Coastal Works Review

Garvin Park – Repair and Extension of Existing Dock and Replacement of Existing Boat Ramp Block: 9A Parcel: 127

October 23, 2019

Authored by: Technical Review Committee - Department of Environment, on behalf of the Director, Department of Environment

Figure 2: Plan extracts showing the proposed docks and boat slips (Reed Consulting Engineers 2019)

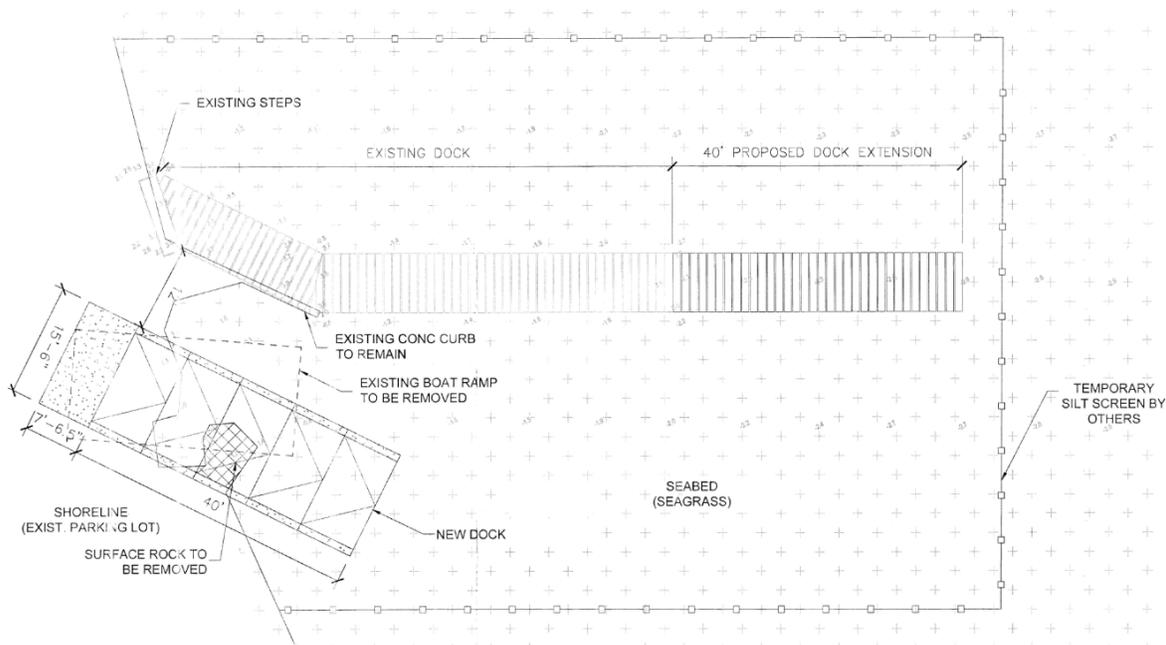
The existing shore perpendicular dock shall be repaired by replacing deteriorated wood framing members and adding deck joists to support the existing TREX deck boards. The proposed dock extension shall measure 40ft long by 8ft 1in wide as shown on stamped approved plans and Figure 2. It will be supported by 8in diameter concrete reinforced PVC pilings auger drilled into the seabed and, as with existing dock section, have TREX decking with a minimum of 1/2in spacing between decking boards. The pilings will be embedded by auger drilling the seabed using machinery mounted on a floating platform.

The boat ramp shall consist of a shore perpendicular reinforced concrete slab measuring 47ft long, 15ft 6in wide and 1ft thick (15 cubic yards of concrete) with 1ft 3in thick concrete curbs along the outer side edges (10 cubic yards of concrete) as shown on stamped approved plans and Figure 2. The area of the existing ramp and the proposed ramp,

including a 2ft wide area around the sides and end of the ramp, shall be excavated from the existing grade to a maximum depth of 4ft to embed the end ramp to 3ft below mean sea level. The seaward footing of the ramp shall be excavated to 5ft below mean sea level. This will result in the excavation of a total volume of 46.2 cubic yards of material. The boat ramp area shall be excavated by shore based excavator. A silt screen will be used to contain the entire area of the works whilst they are being carried out. As a part of the works the application also proposes a geotechnical survey to establish the substrate of the seabed to the pile embedment depth of 3ft below seabed level. It is proposed that at 3 locations along the length of the proposed dock, a steel rod shall be hammered into the seabed using a hydraulic hammer. No silt screens are proposed to be used at this stage as there should be very little disturbance.
